10.2 Turbine Generator

The information in this section of the reference ABWR DCD, including all subsections, tables and figures, is incorporated by reference with the following departures and supplements.

Figure 10.2-1 Turbine Stop Valve Closure Characteristic

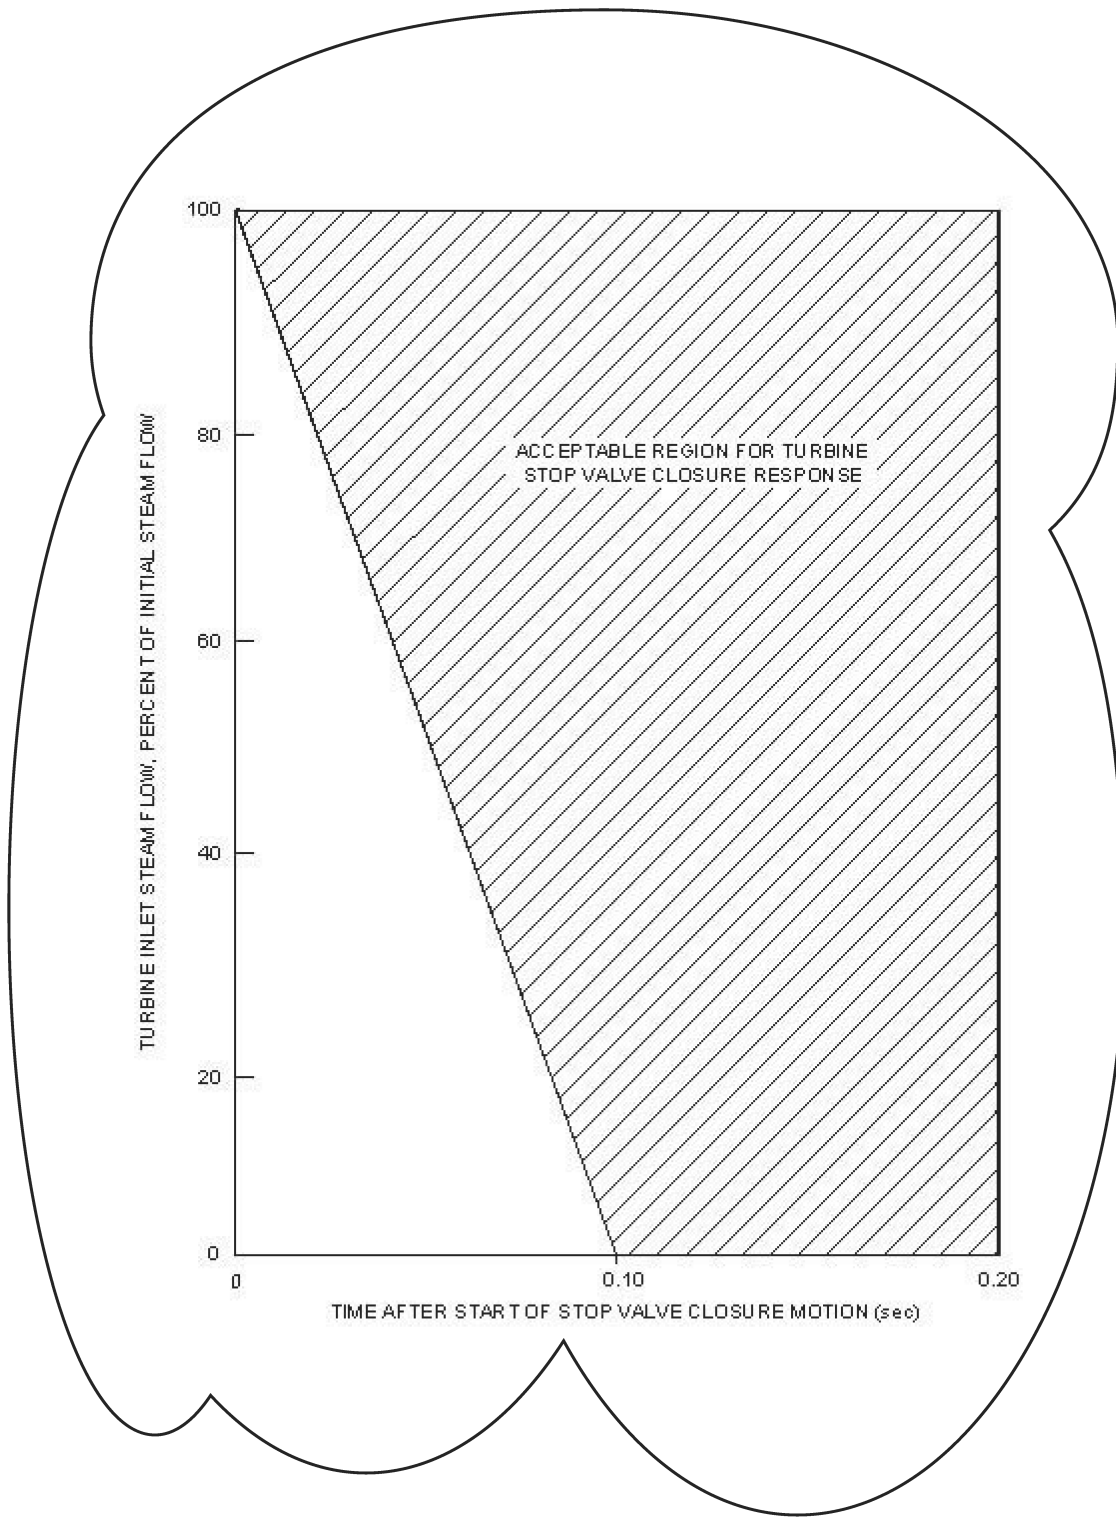
STD DEP Admin (Figure 10.2-1)
